SUBJECT: CONSTRUCTION MANAGEMENT AT RISK (CMAR) SERVICES – PRECONSTRUCTION AND CONSTRUCTION SERVICES – MEDICAL EXAMINER'S OFFICE (REBID)

City of Jacksonville
Medical Examiner's Office
4368 N. Davis Street, Jacksonville, FL 32209
GMP Estimate

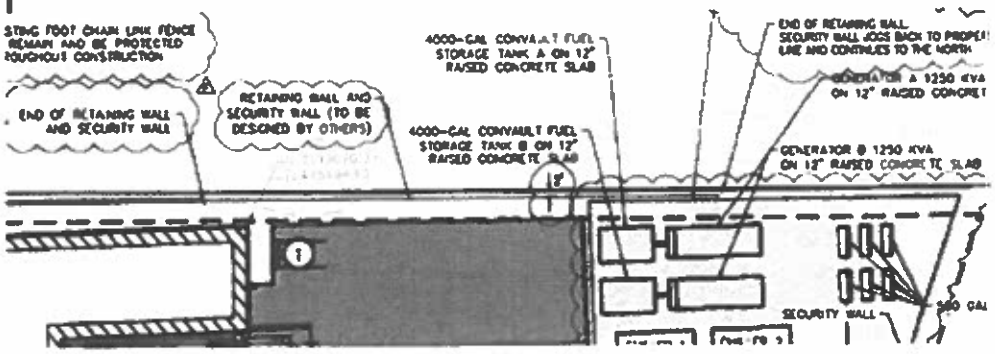
Please provide a detail for the portion of the gravity wall that switches to a retaini
Currently we are figuring the retaining wall to be a segmented block retaining wal
C512.
Does the site CMU security wall sit on top of the retaining wall? Provide a detail fc
